PARKWAY PLACE SUBDIVISION

APPLICATION NUMBER 2 DATE January 3, 2013
APPLICANT Parkway Place Subdivision
REQUEST Subdivision

DETAIL SITE PLAN

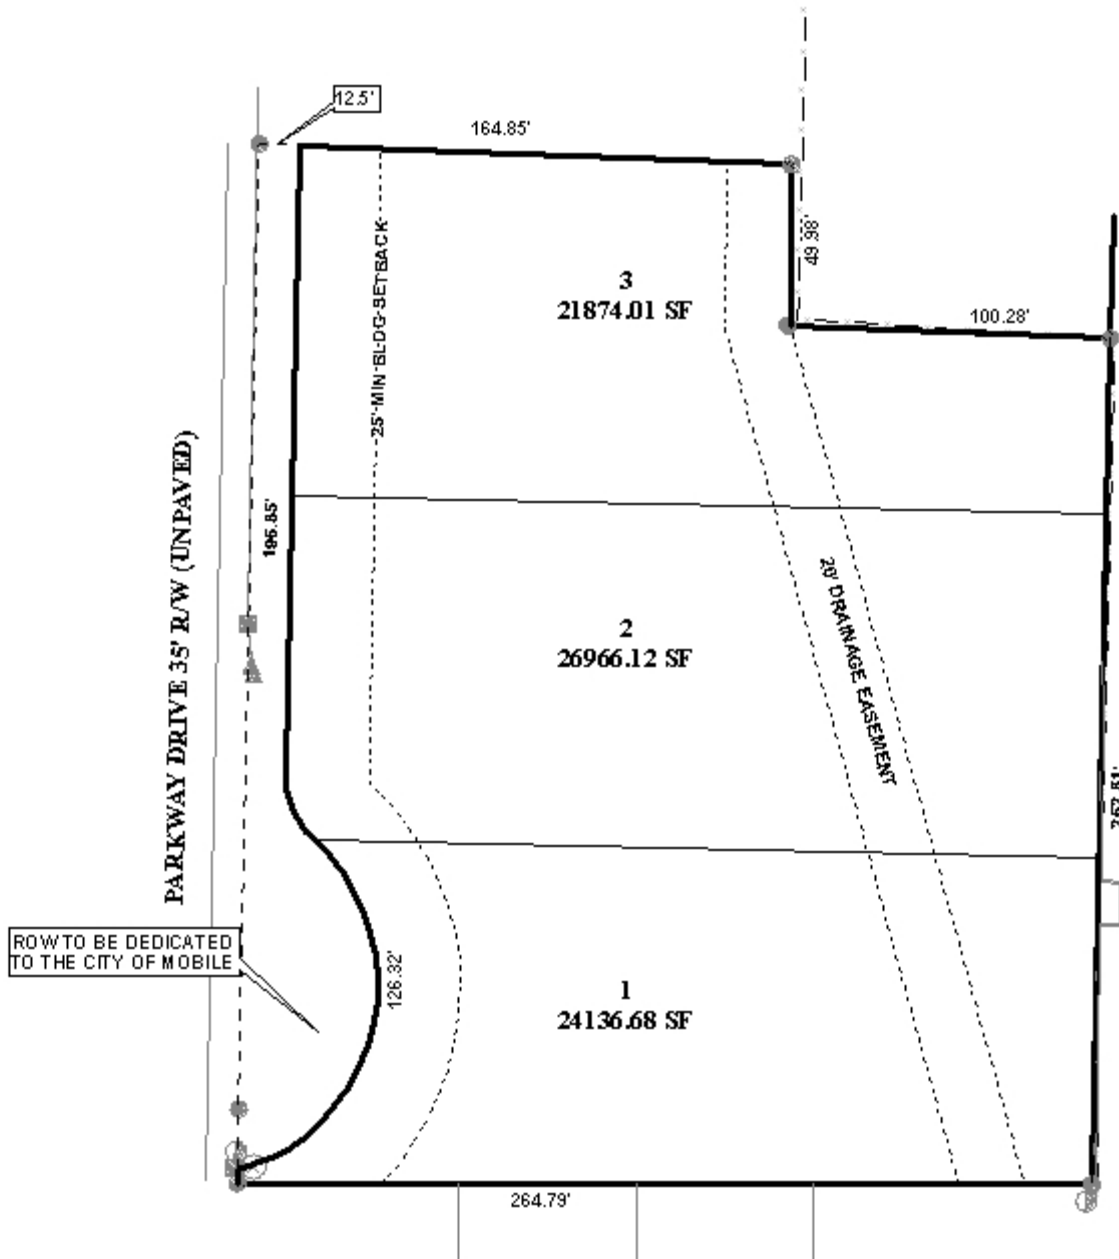
The 25-foot minimum building setback line, required in Section V.D.9., is not identified on the preliminary plat. Lines on the plat appear to depict a 25-foot front setback, 10-foot side yard setbacks, and a 25-foot minimum rear yard setback. The lines also enclose an area, implying a maximum building footprint. The Subdivision Regulations only regulate the front yard setback. The Zoning Ordinance would minimally require a 25-foot front setback and an 8-foot side and rear yard setback for an R-3 site, and would limit the maximum building footprint for the site to be 45%.

- 1) Dedication of right-of-way sufficient to provide 30-feet from the centerline of Parkway Drive;
- 2) Dedication of right-of-way sufficient to provide half of a turn-around complying with Sections V.B.14. and V.B.15. of the Subdivision Regulations, or at minimum meeting the requirements of the 2009 International Fire Code, as locally adopted;

- 3) Revision of the plat to label the 25-foot setback line, after any required dedication;
- 4) Revision of the plat to depict a common detention area, if one will be provided;

- 5) Revision of the plat to label each lot with its size in square feet, or placement of a table on the plat with the same information; and
- 6) Placement of a note on the plat stating that approval of all applicable Federal, state and local agencies is required for endangered, threatened or otherwise protected species, if any, prior to the issuance of any permits or land disturbance activities.

The revised plat additionally shows a 20-foot wide drainage easement which cuts across the rear one-third of the proposed lots. A note should be placed on the final plat, if approved, stating that no permanent structures shall be placed in the drainage easement.

A revised plat was submitted, reflecting all requested revisions.

- 1) placement of a note on the final plat stating that each lot is limited to one curb-cut each, with the size, design and location to be approved by Traffic Engineering and conform to AASHTO standards;

- 2) retaining of the lot size, setback, easement, endangered species note, and dedication information depicted on the preliminary plat;
- 3) placement of a note on the final plat stating that no permanent structures may be placed within the drainage easement;
